HURRICANE CITY UTAH

Hurricane Planning Commission Meeting Agenda

July 25, 2024
5:00 PM

Current: Light Industrial/Business
Change: Commercial of Mixed Use

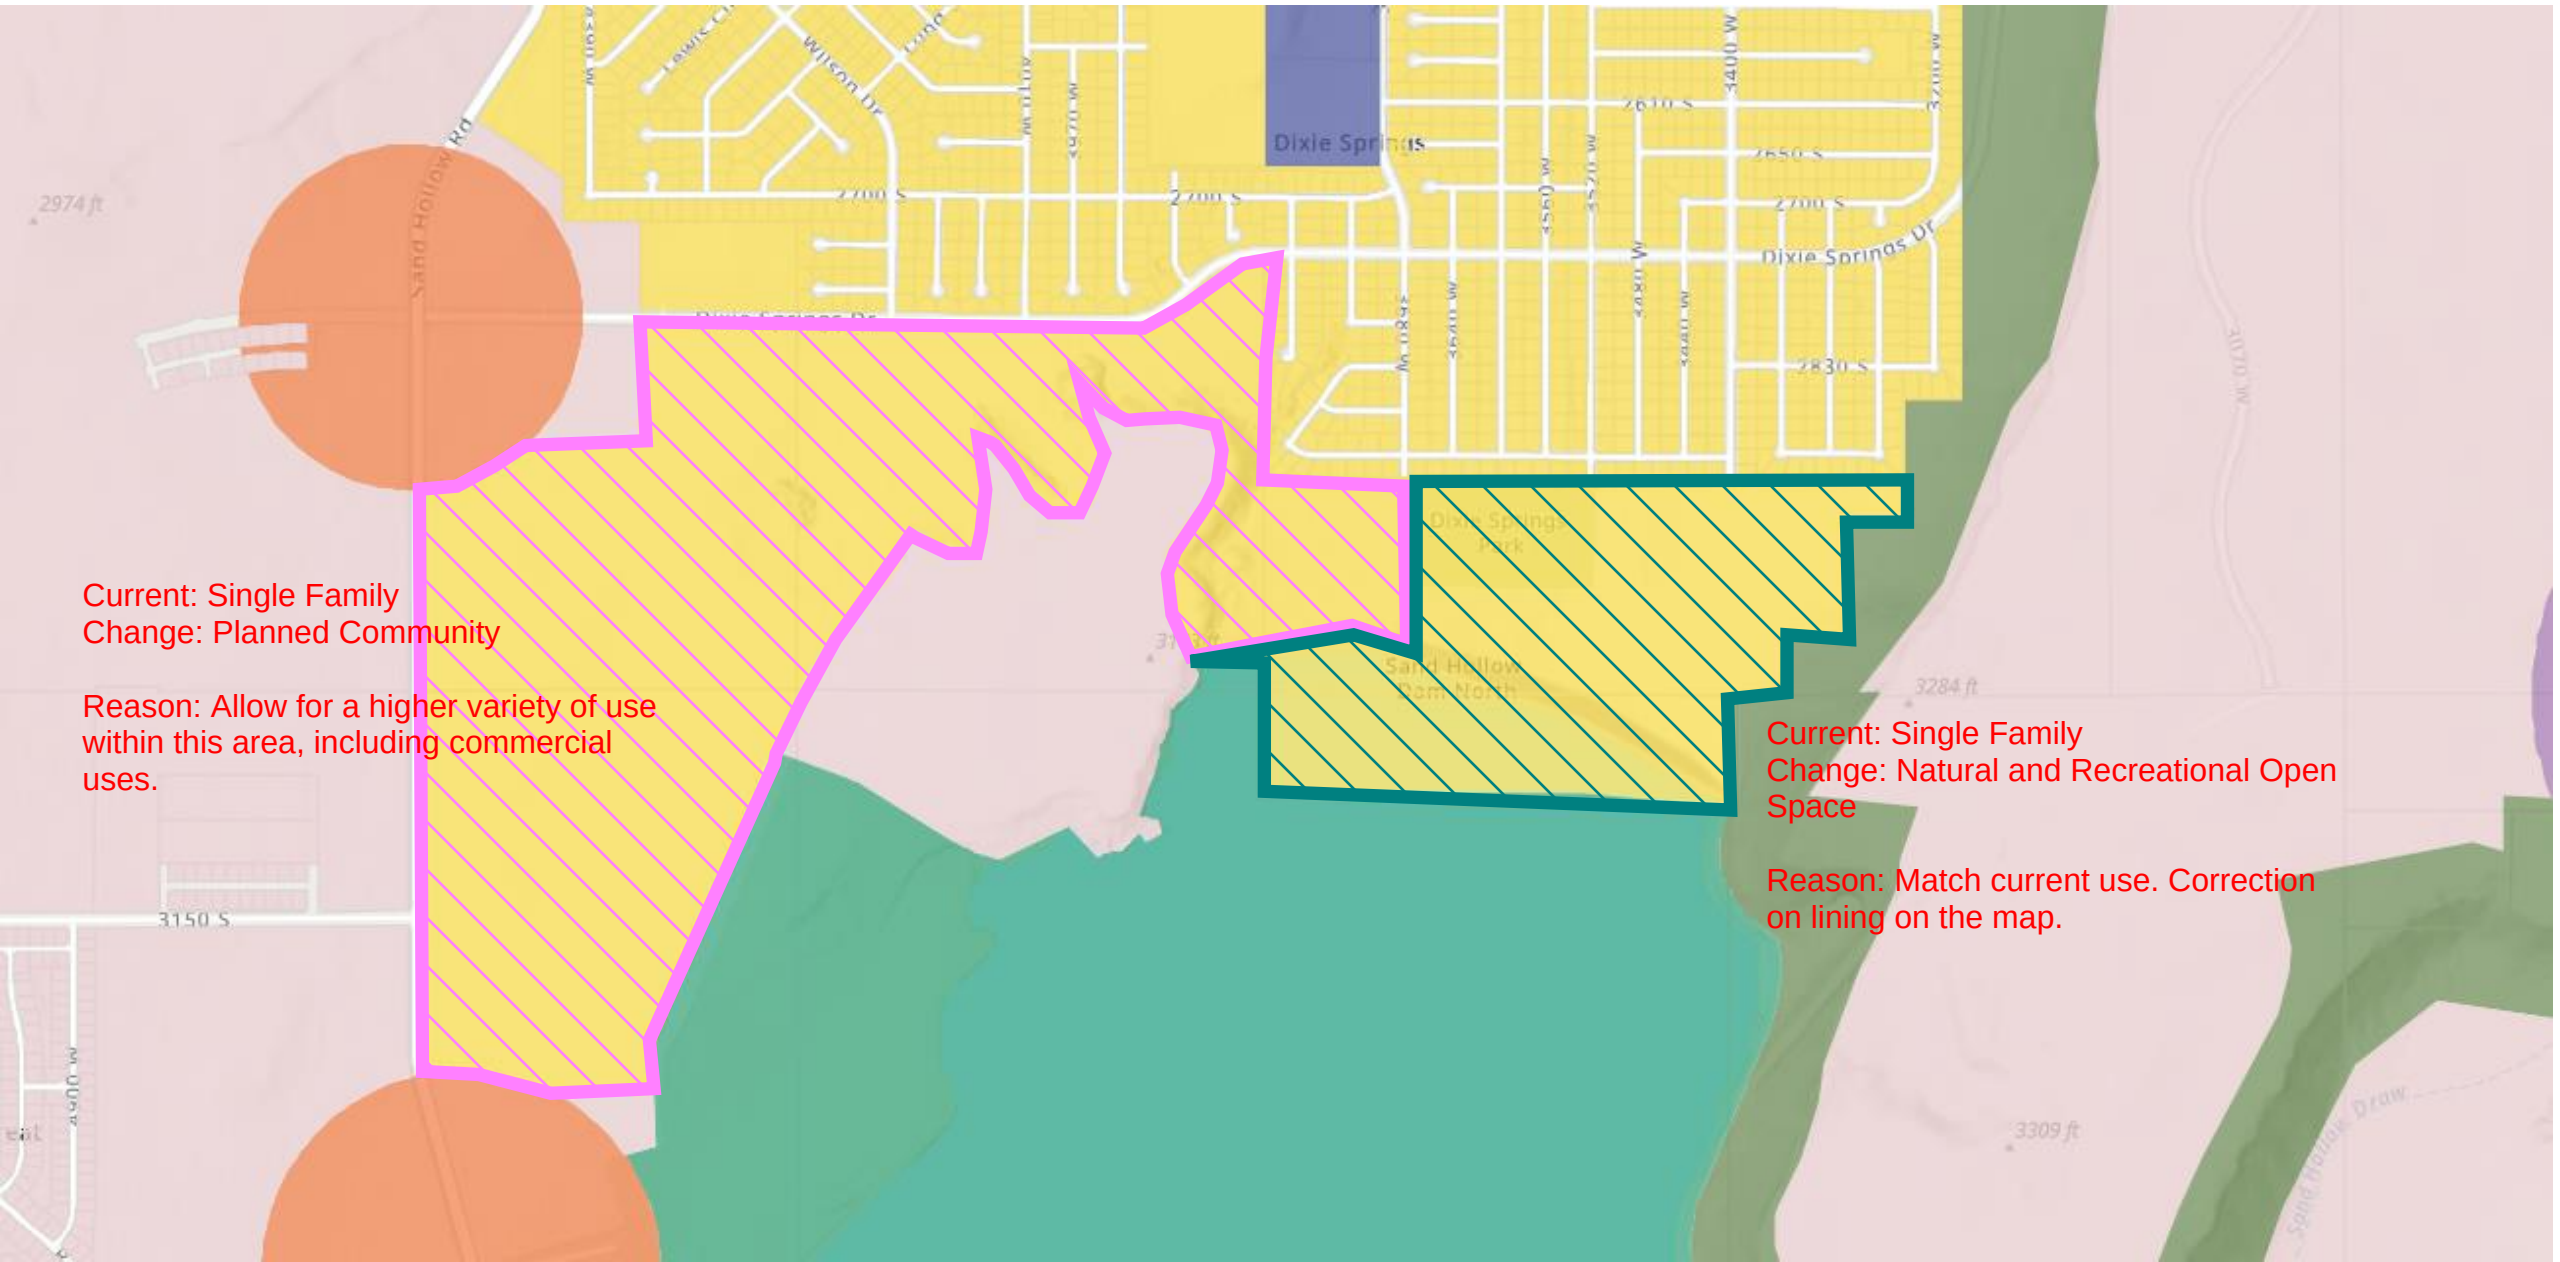
Reason: With the number of new homes,
a commercial or mixed use zoning might
be a better fit. Commercial uses can
take place in Light Industrial/Business
areas.

Current: Single Family
Change: Natural and Recreational Open
Space

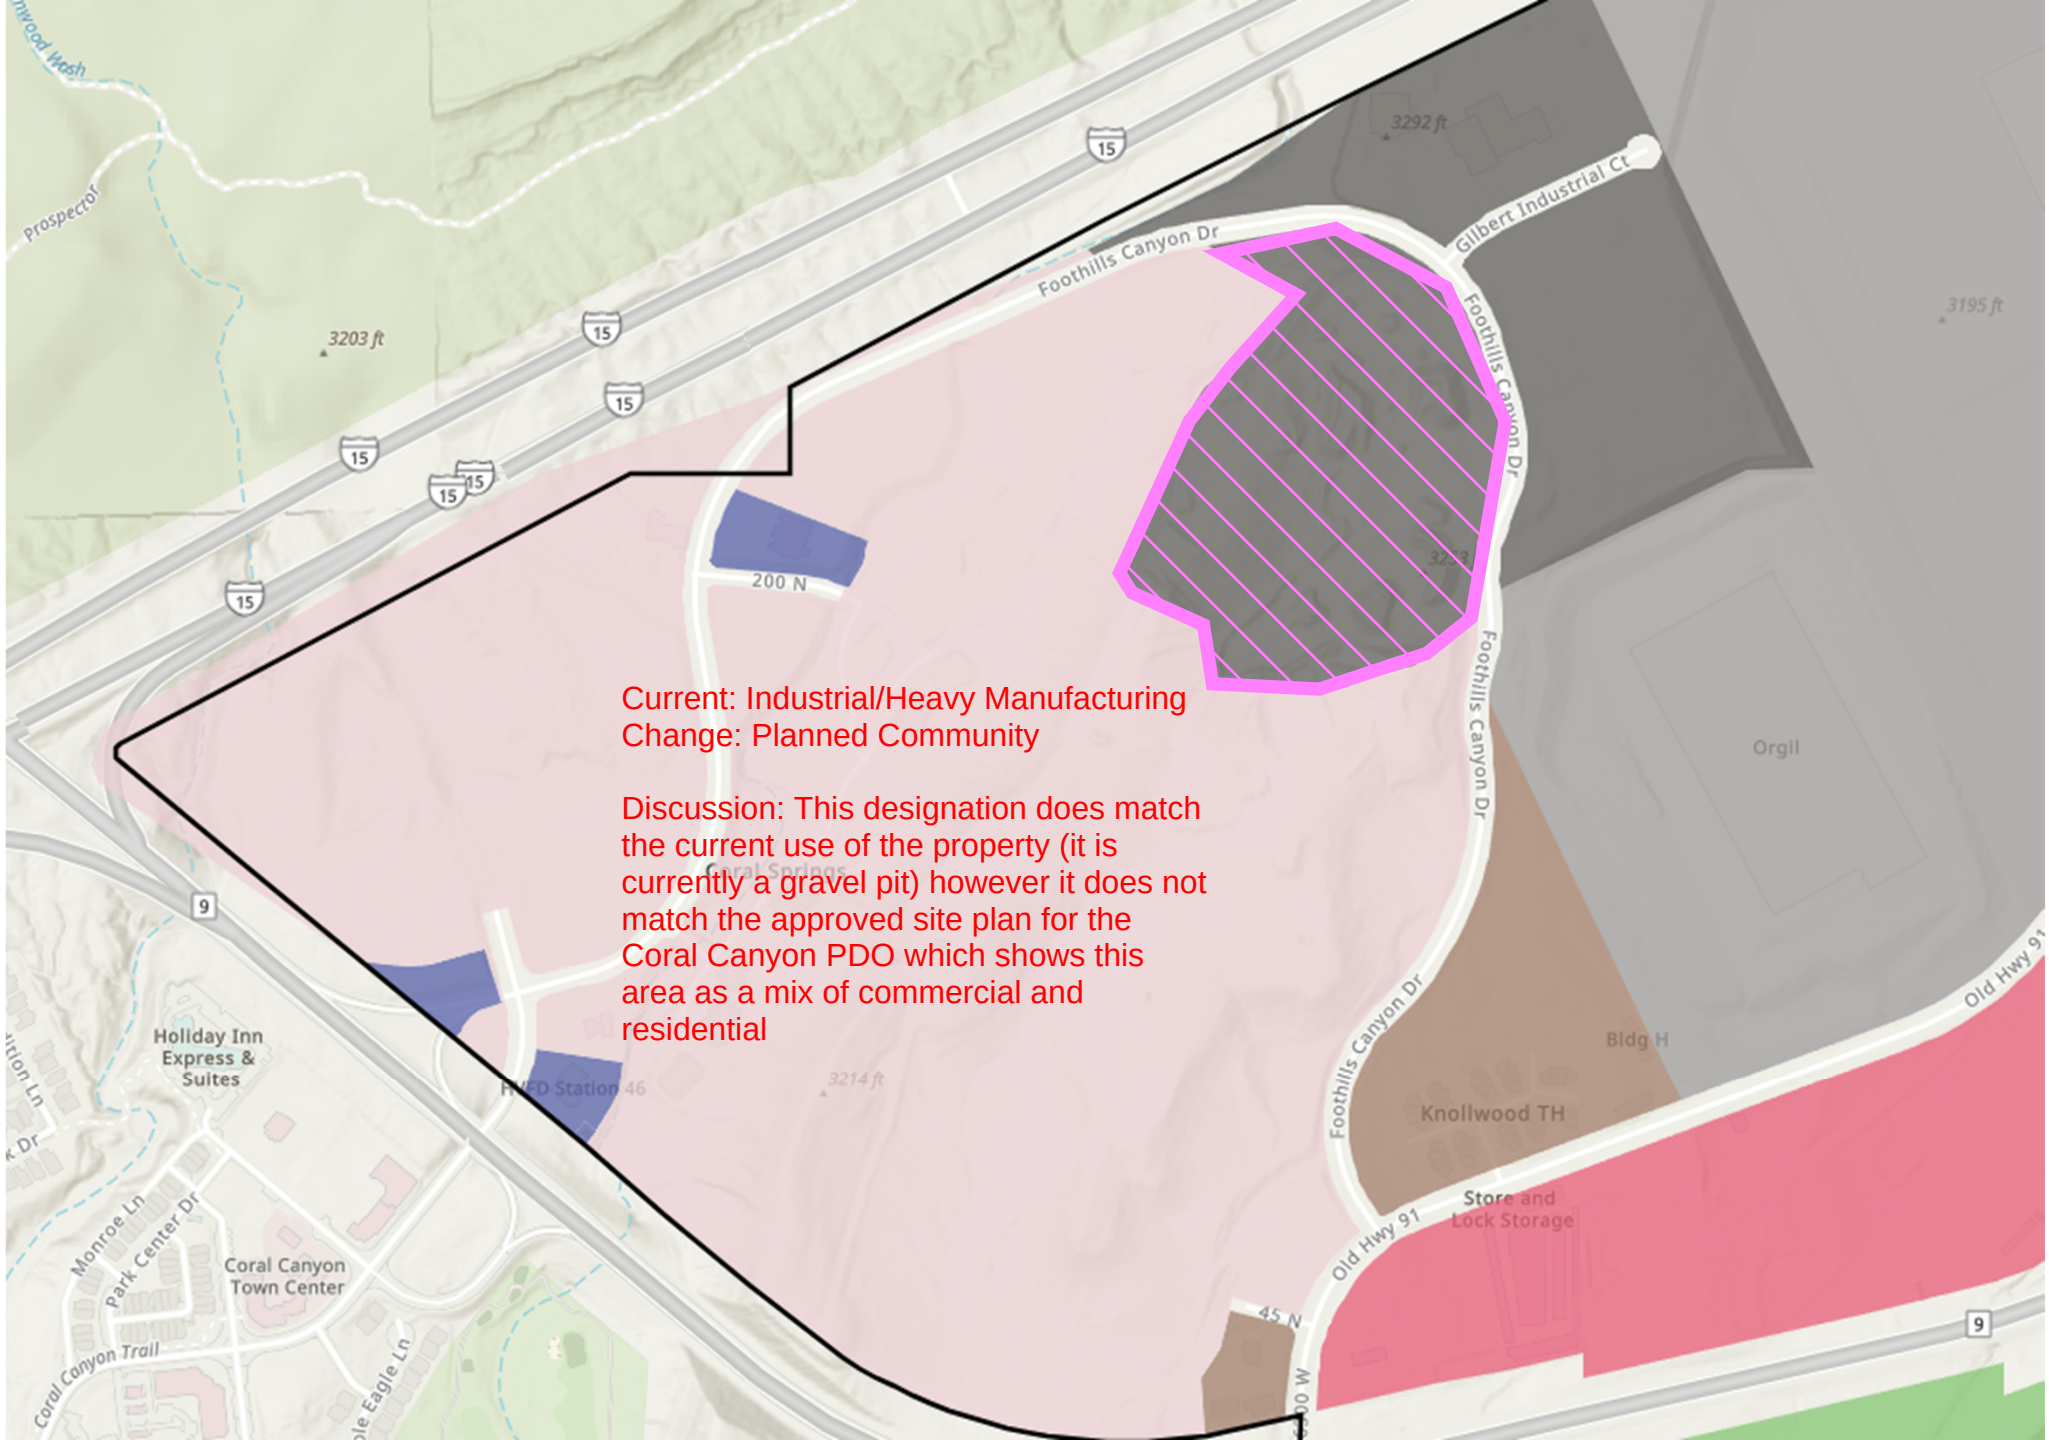
Reason: Match current use. Correction
on lining on the map.

Current: Industrial/Heavy Manufacturing
Change: Planned Community

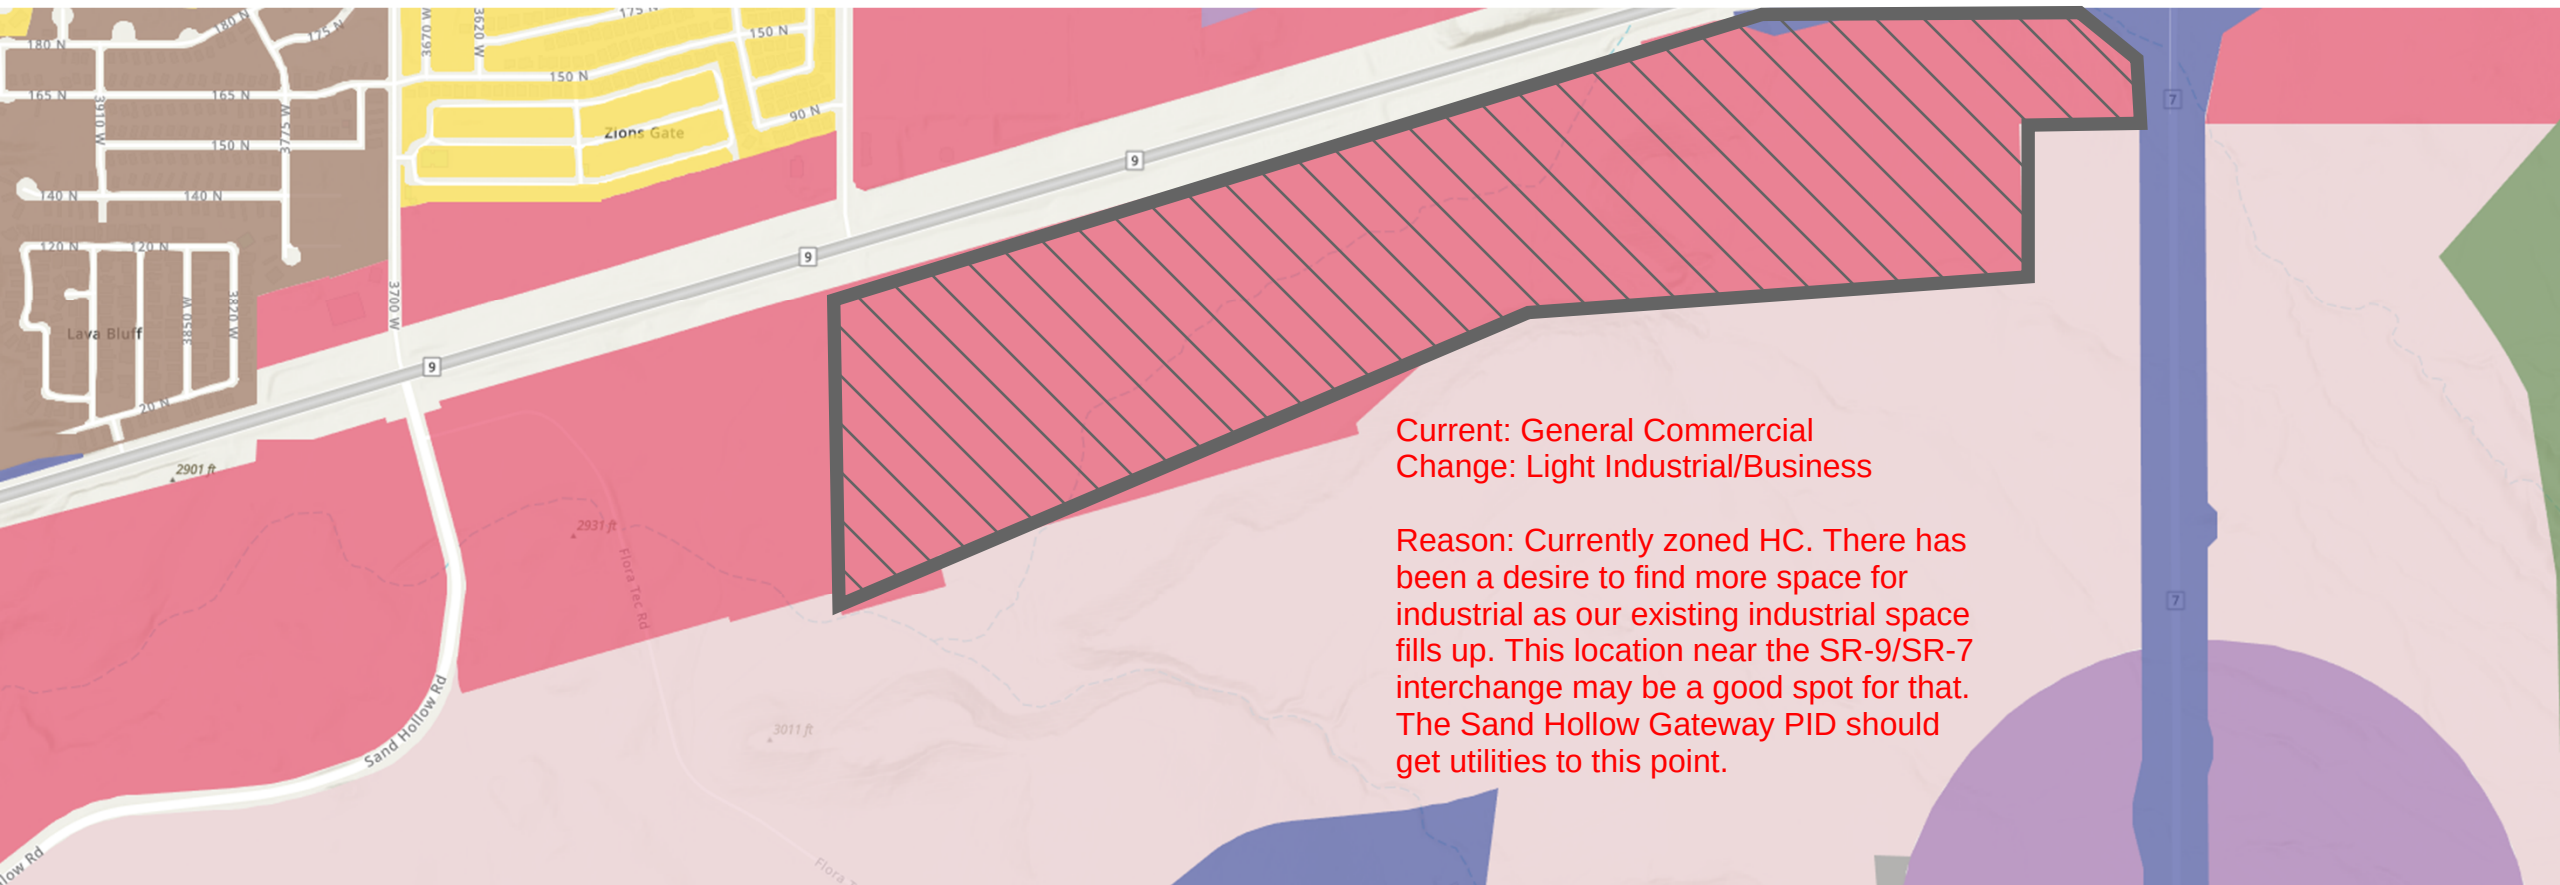
Discussion: This designation does match the current use of the property (it is currently a gravel pit) however it does not match the approved site plan for the Coral Canyon PDO which shows this area as a mix of commercial and residential
